Proposed change to Figure 178B-9 (RTS update state diagram) (in support of comment #403)

Adee Ran, Cisco

Figure 178B-9—RTS update state diagram

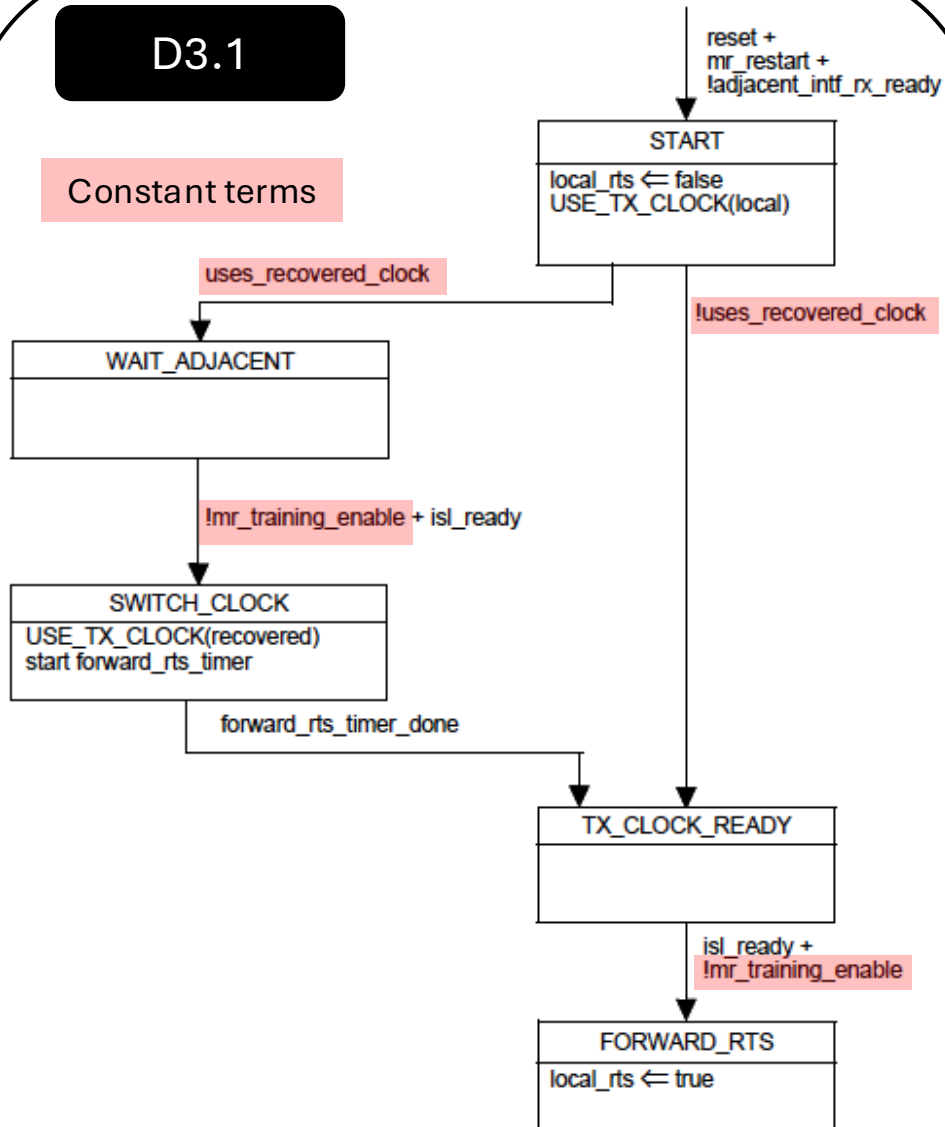
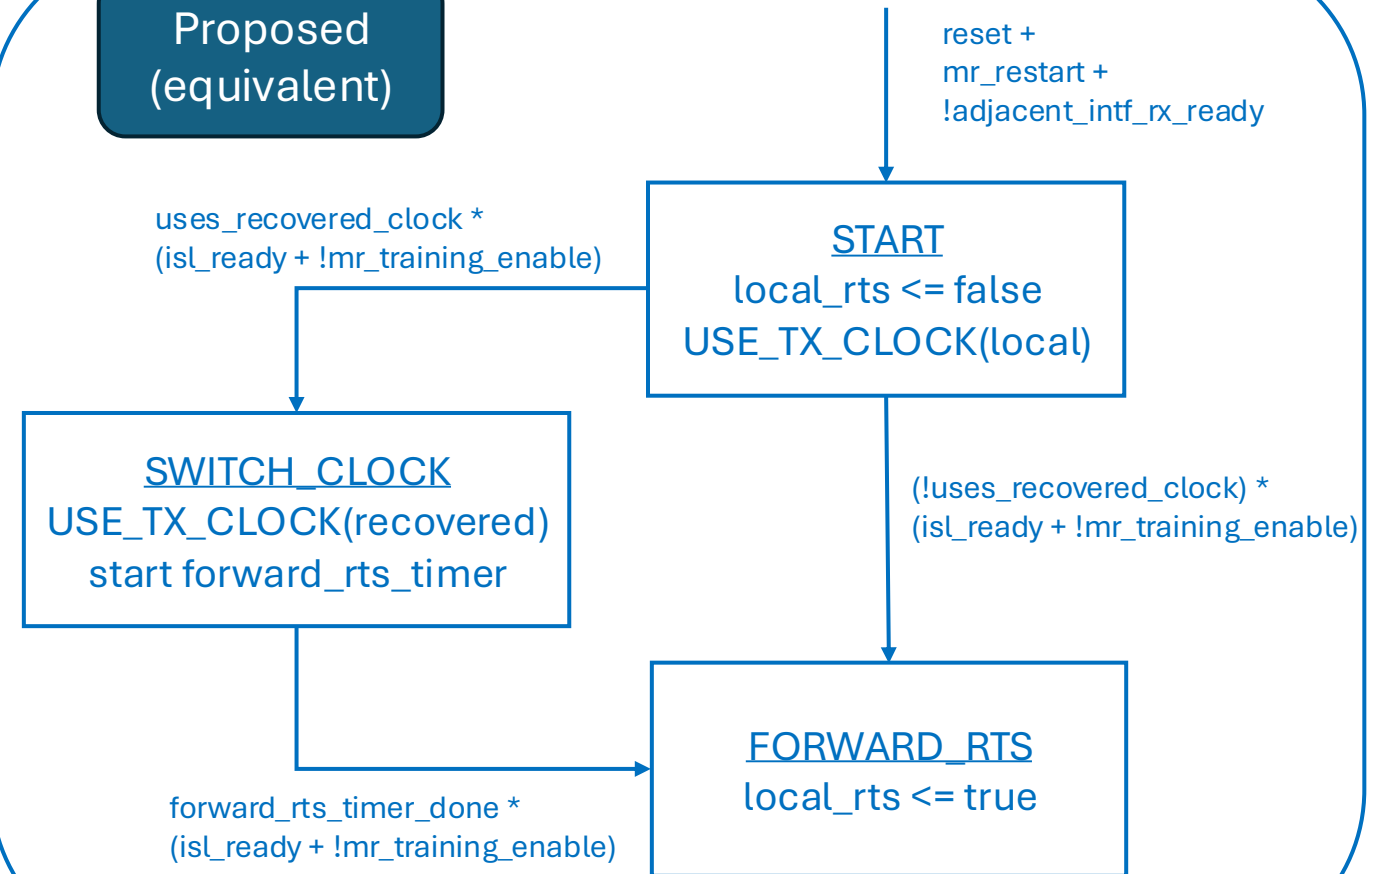
- Simplification of Figure 178B-9 has been proposed in [slavick_3dj_03_2603](#) and [mascitto_3dj_01_2605](#).
- The previous proposals did not account for possible change of `isl_ready` during the `forward_rts_timer`, so were not exactly equivalent to the existing state diagram.
- The current proposal has modified transition conditions to make the 3-state diagram equivalent to the original.
 - As shown in the next slide, noting the constant terms in the conditions.
- The proposed simplification would make the diagram easier to understand and help readers, implementers, and troubleshooters.

- Propose to simplify Figure 178B-9 as shown on slide 3. The functionality is fully equivalent.
- No other changes are required.

Proposed
(equivalent)
